## REQUEST FOR INFORMATION (RFI) #3

**Solicitation Description:** CDBG FUNDED HAMILTON CITY LIBRARY & COMMUNITY HALL ADA UPGRADE

**RFI Number:** 003

1. 19136\_A1\_SITE PLAN\_19-1218
2. 08 71 00- FINISH HARWARE R

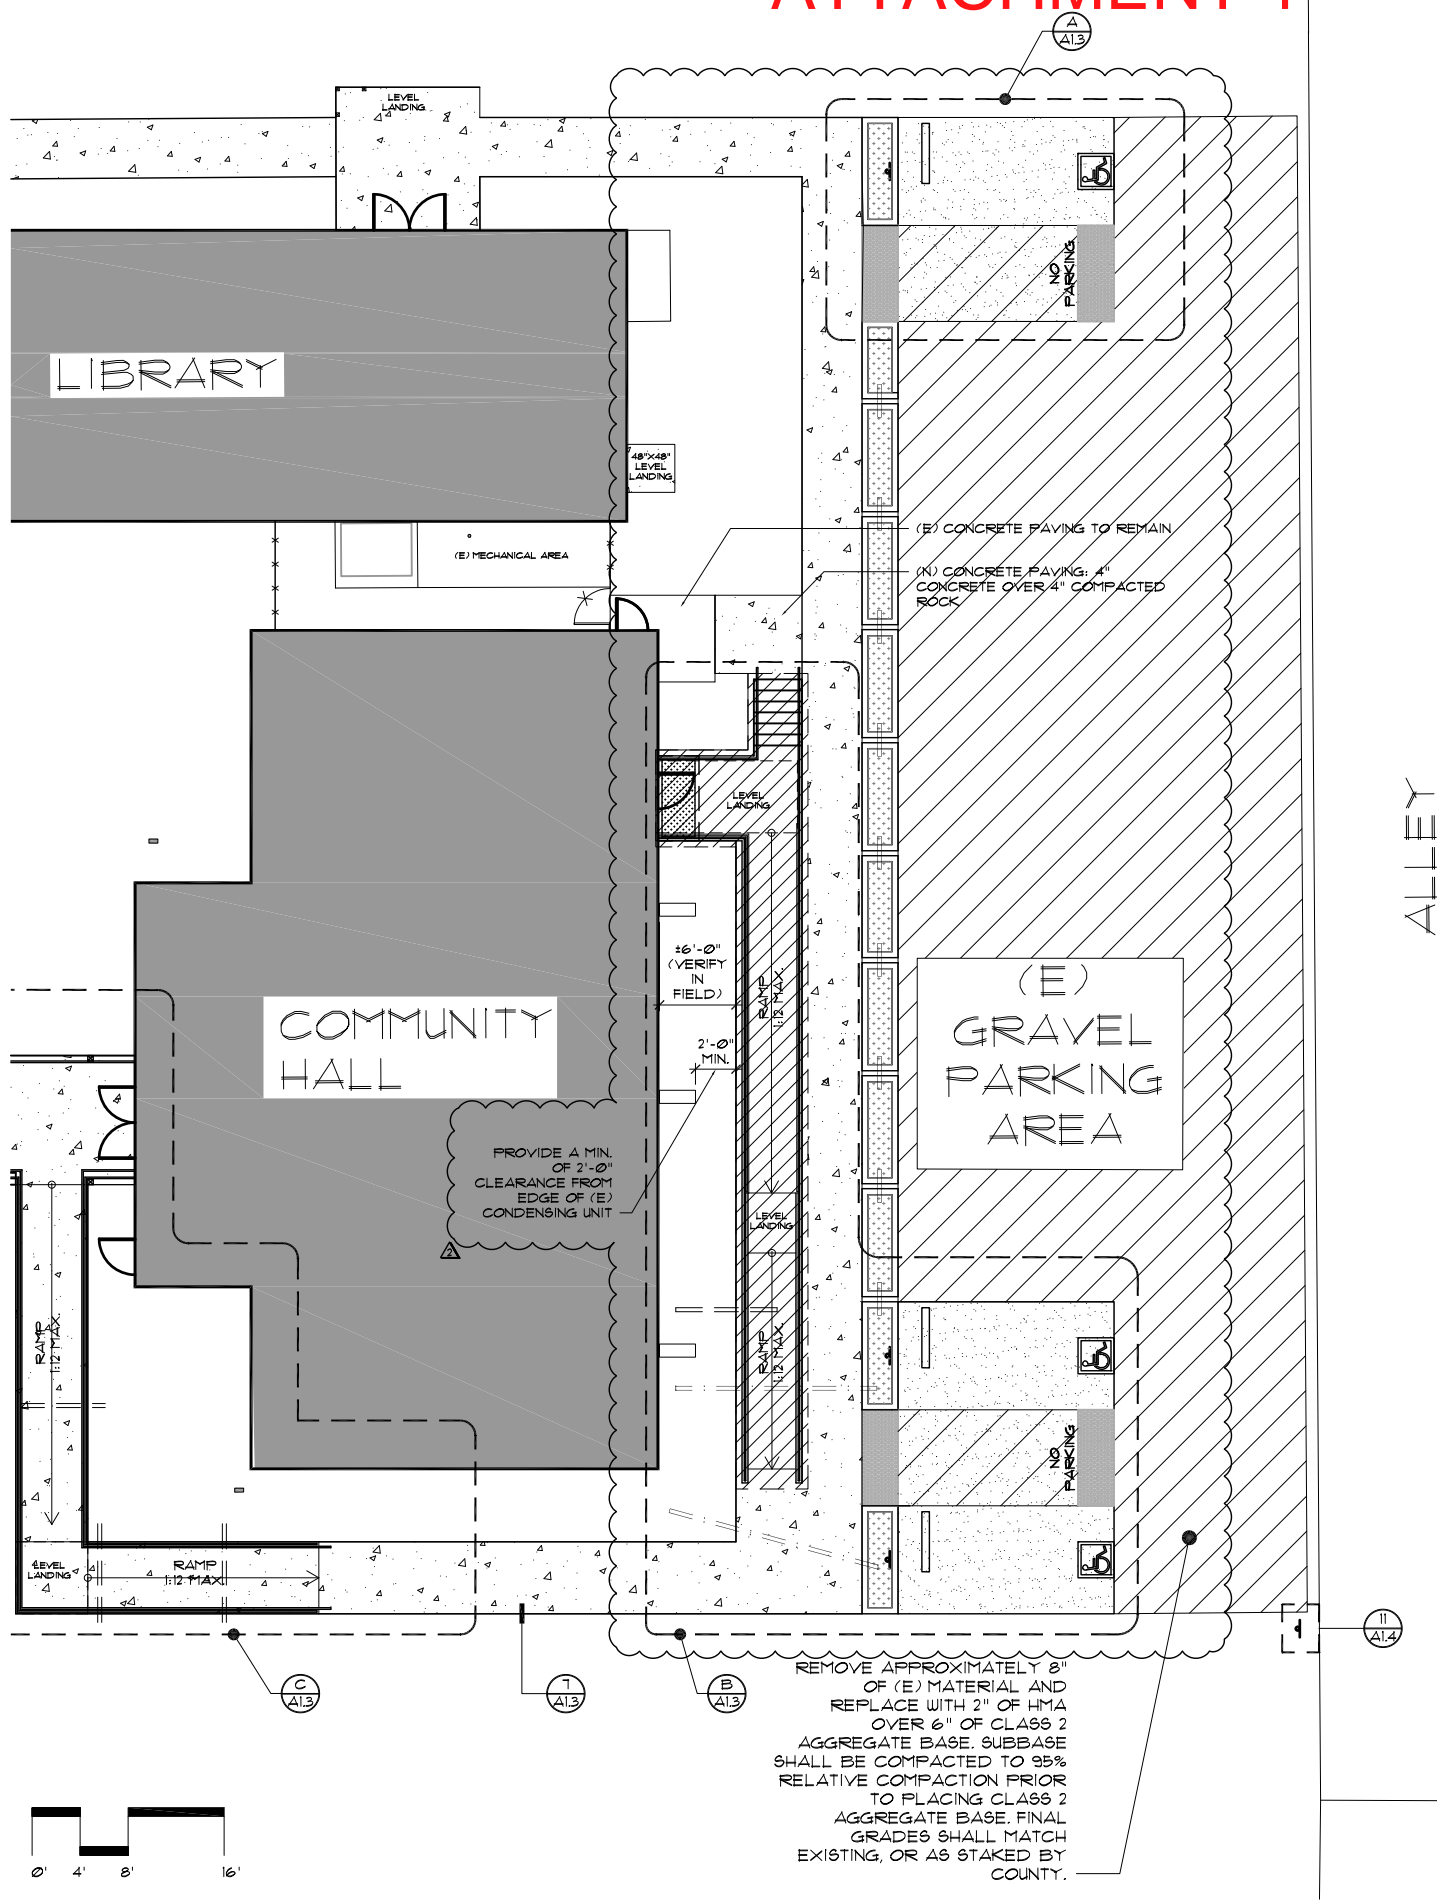
- 9. Response:** New concrete not to be epoxied into building foundation wall..
- 10. Question:** The new metal ramp system at the back of the community hall appears to scale less than 2' off the back wall of the building. Will this offset need to be larger to accommodate the (e ) mini- split condensing units that are in this space? Will this affect the design size of the metal landing/ramp system?

- 10. Response:** Re-locate pre-manufactured ramp, walkway and accessible parking to provide 6'-0" clear from side of building. See enclosed revised site plan. Please note the paving quantities at the parking lot are reduced.
